MIL-R-83536/10A
AMENDMENT 3
13 May 1999
SUPERSEDING
AMENDMENT 2
30 September 1996

MILITARY SPECIFICATION SHEET

RELAYS, ELECTROMAGNETIC, ESTABLISHED RELIABILITY, DPDT, LOW LEVEL TO 10 AMPERES, PERMANENT MAGNET DRIVE, HERMETICALLY SEALED, ALL WELDED, TRANSIENT SUPPRESSED DC COILS

FIGURE 1. Dimensions and configurations - Continued."

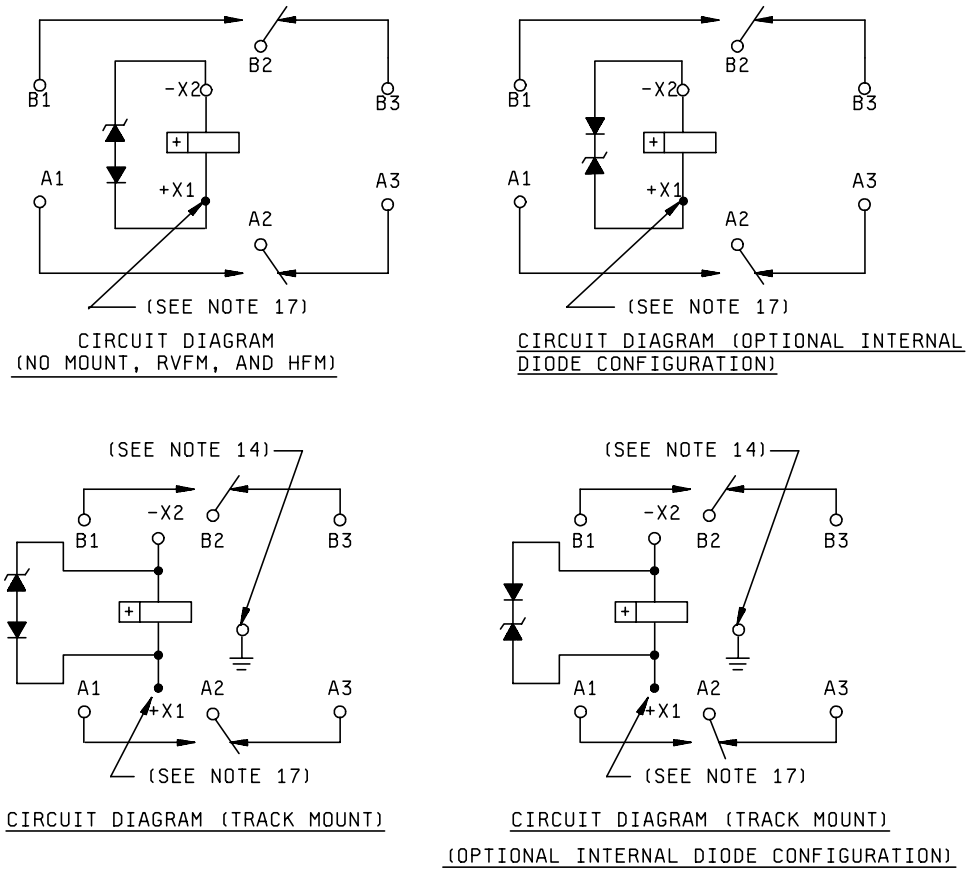
* FIGURE 1, delete and substitute:
